- Individual or group. (58 Responses)**
- Name (35 Responses)**
- Organization (35 Responses)**
- Group Name (23 Responses)**
- Lead Contact (23 Responses)**
- Question 1 (49 Responses)**
- Question 1 Comments (58 Responses)**
- Question 2 (47 Responses)**
- Question 2 Comments (58 Responses)**
- Question 3 (40 Responses)**
- Question 3 Comments (58 Responses)**
- Question 4 (52 Responses)**
- Question 4 Comments (58 Responses)**

William R. Harris
No
COMMENTS OF THE FOUNDATION FOR RESILIENT SOCIETIES (Comment 1 of 2 submitted 10-10-2014) TO THE STANDARD DRAFTING TEAM NERC PROJECT 2013-03 – STANDARD TPL-007-1 TRANSMISSION SYSTEM PLANNED PERFORMANCE FOR GEOMAGNETIC DISTURBANCE EVENTS October 10, 2014 Answer to Question 1: No, we do not agree with these specific revisions to TPL-007-1. Detailed responses are below. Requirement R3 should contain steady state voltage “limits” instead of the subjective term “performance.” Measure M3 should contain steady state voltage “limits” instead of the subjective term “performance.” Table 1, “Steady State Planning Events” has been changed to allow “Load loss as a result of manual or automatic Load shedding (e.g. UVLS) and/or curtailment of Firm Tr

Figure 1. American Electric Power (AEP) Geomagnetically Induced Current Data Presented at February 2013 GMD Task Force Meeting

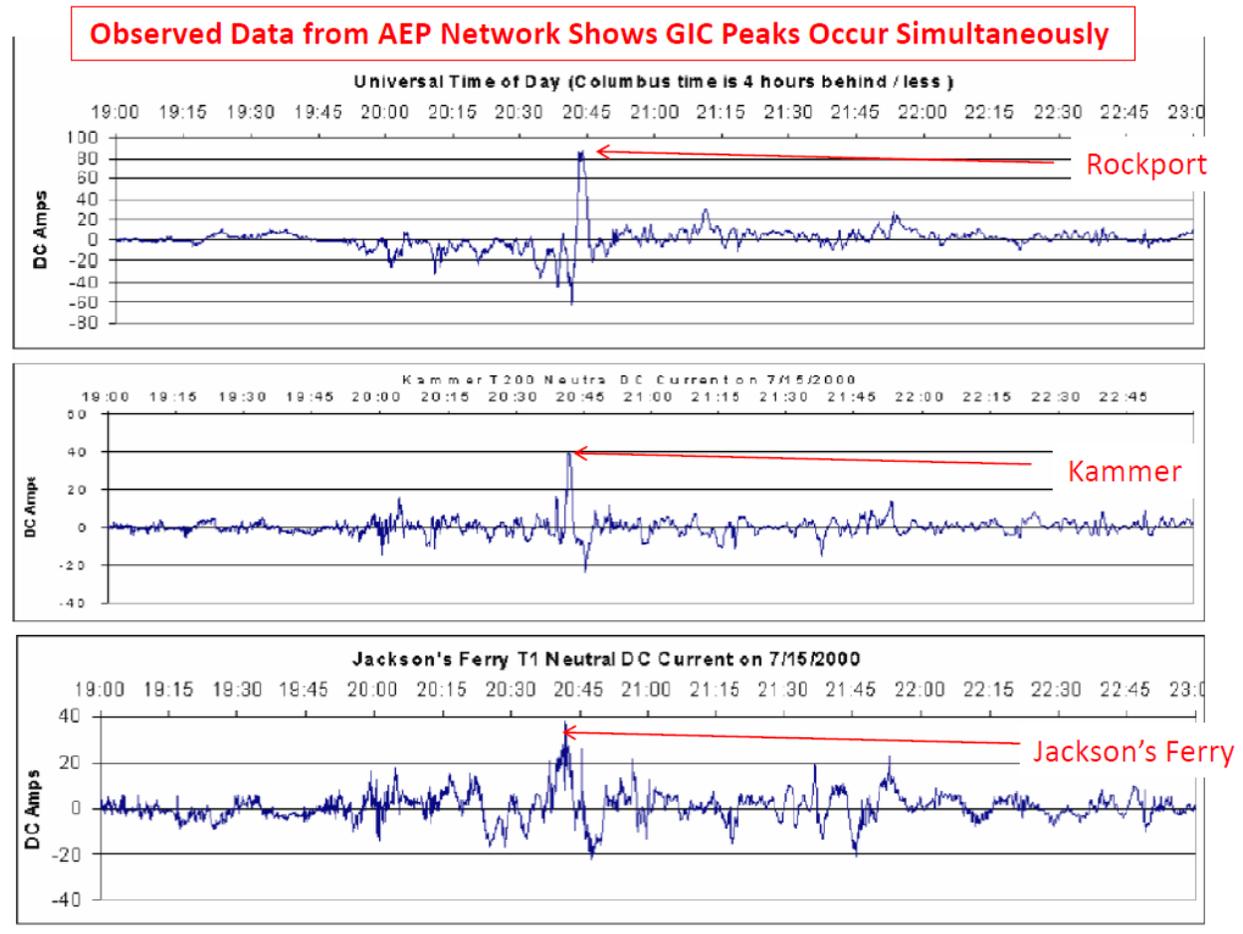
In this comment, we present data to show the NERC “hotspot” conjecture is inconsistent with real-world observations and the “Benchmark GMD Event” is therefore not scientifically well-founded.² Figures 1 and 2 show simultaneous GIC peaks observed at three transformers up to 580 kilometers apart, an exceedingly improbable event if NERC’s “hotspot” conjecture were correct.

According to Faraday’s Law of induction, geomagnetically induced current (GIC) is driven by changes in magnetic field intensity (dB/dt) in the upper atmosphere. If dB/dt peaks are observed simultaneously many kilometers apart, then it would follow that GIC peaks in transformers would also occur simultaneously many kilometers apart. Figure 3 shows simultaneous dB/dt peaks 1,760 kilometers apart during the May 4, 1988 solar storm.
